IEEE 802.3cg MDI connector Limitations

Amrik Bains - Cisco Systems
George Curtis - Cisco Systems
Ed Kliewer - Cisco Systems

Current 48 port Switch (1RU) using 4 Pair Stacked RJ45

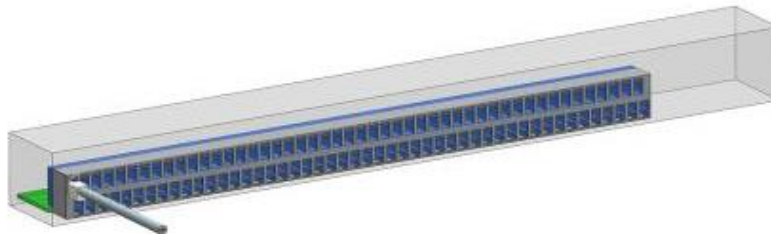
- Support same connector for 18 – 26 AWG capable of high port density on a switch

Future 96 port Switch (1RU) using Single Pair Stacked connectors 22 AWG to 26 AWG

Same switch using every second port with 18 AWG, but same connector/pin pitch
